(Variation 2) 157 Levi Road Rolleston Foodstuffs (South Island) Properties

Statement of evidence of John Lonink on behalf of Selwyn District
Council – Urban Design

Date: 20 February 2025

Attachment 1- Map 1 Existing ODP combined

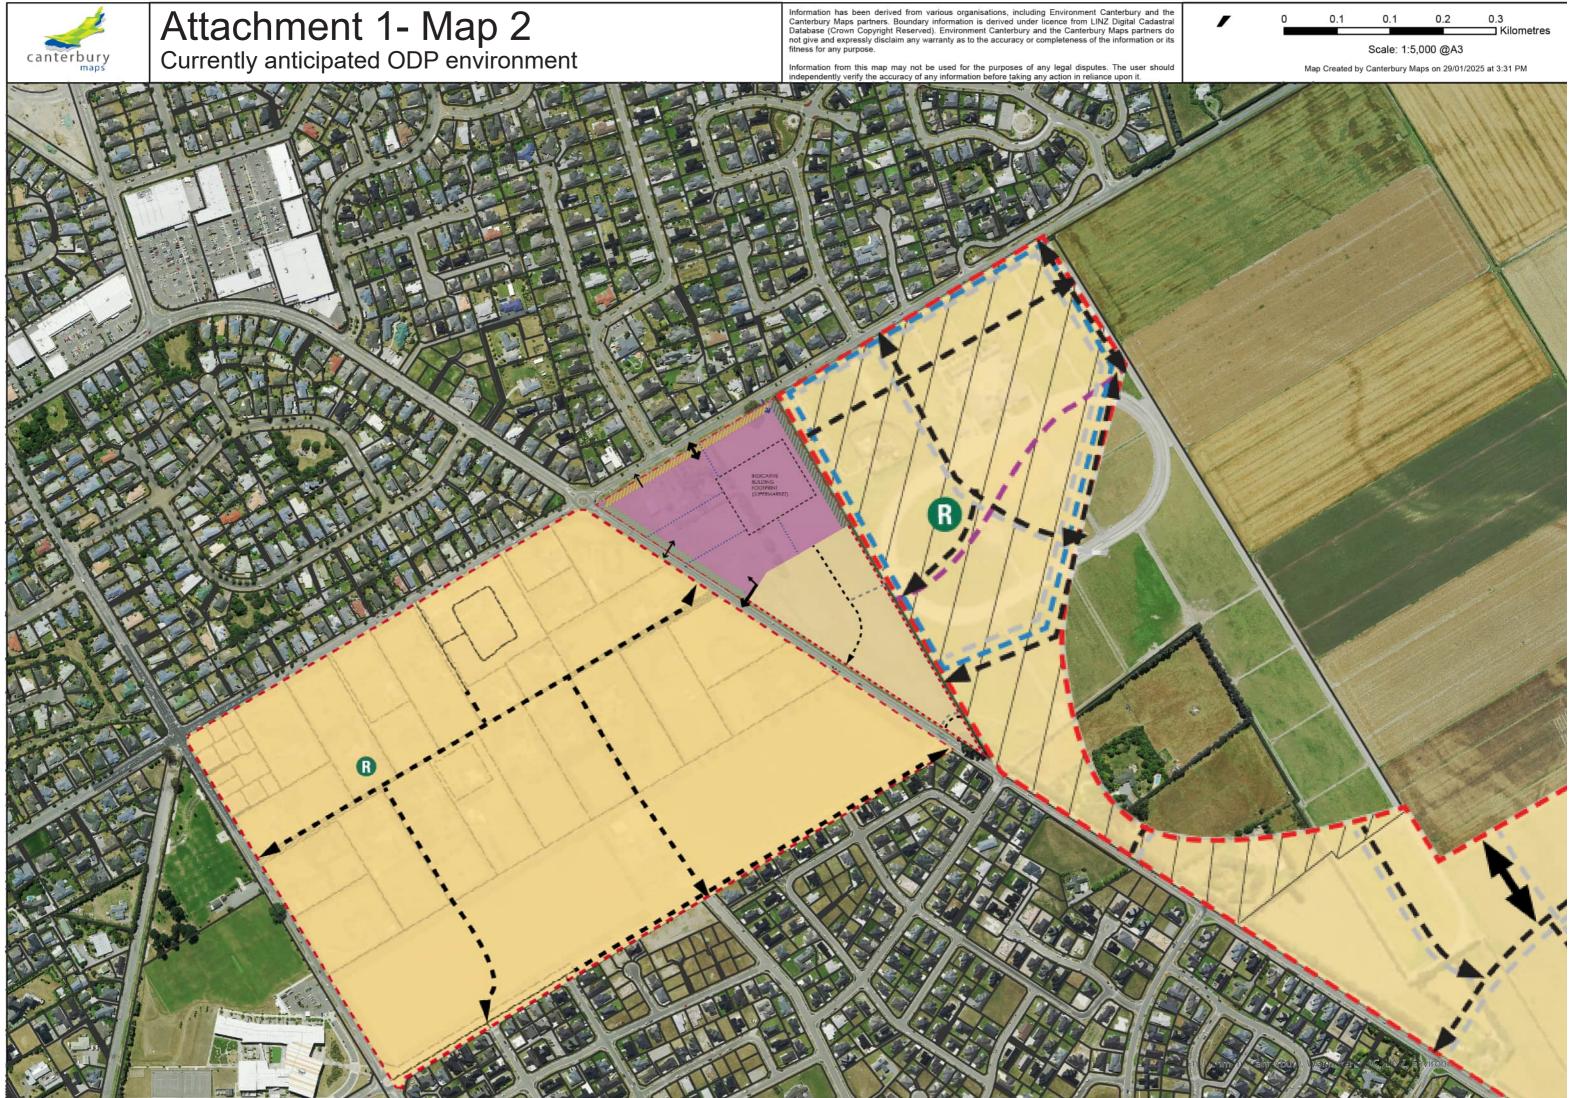
- As highlighted in the applicants' planner's report¹ The three relevant ODP's for this plan change are for DEV-RO1 (Site), DEV-RO2 and DEV-RO12.
- Map 1 within Attachment 1 shows how the three outline development plans currently interact. As can be seen the various indicative road, pedestrian and cycle connections do not fully align between the three plans. However, the intention of through connections is shown in all the plans, although not to the same extent.

As highlighted in the three maps shown in Attachment 1, the existing outline development plans for the Site and surrounding area anticipate a good level of permeability. Although not all the indicative roads and pathways fully align, the intention is evident as all plans show road and pedestrian/ cycle connections through to neighbouring sites. As the last map in Attachment 1 shows, the proposed ODP will sever these connections, significantly reducing the level of connectivity through the Site and the wider residential neighbourhoods that adjoin the Site.
